PROJECT NAME: Lorain County Commissioners
2016 Roof Replacement / Repair Project

ADDENDUM NO. 1

May 9, 2016

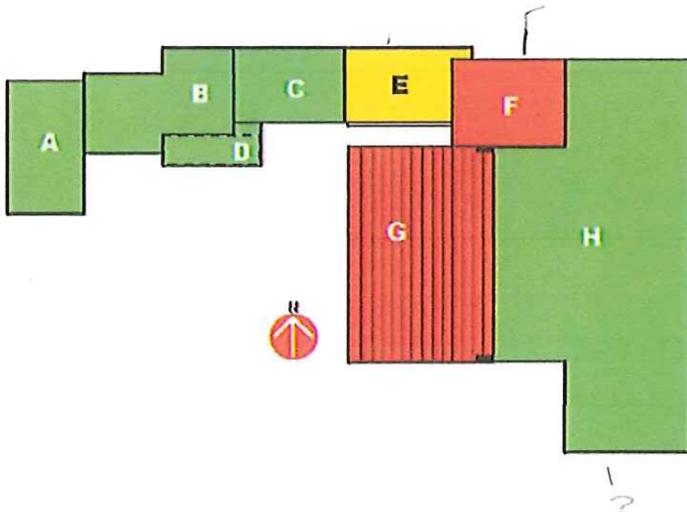
1. Are the drains (5) part of the base bid for replacement?

Yes 5 drains with up to 5' of interior cast iron drain piping with cast iron bowl, basket, gasket, sealant, and miscellaneous parts to make all watertight.
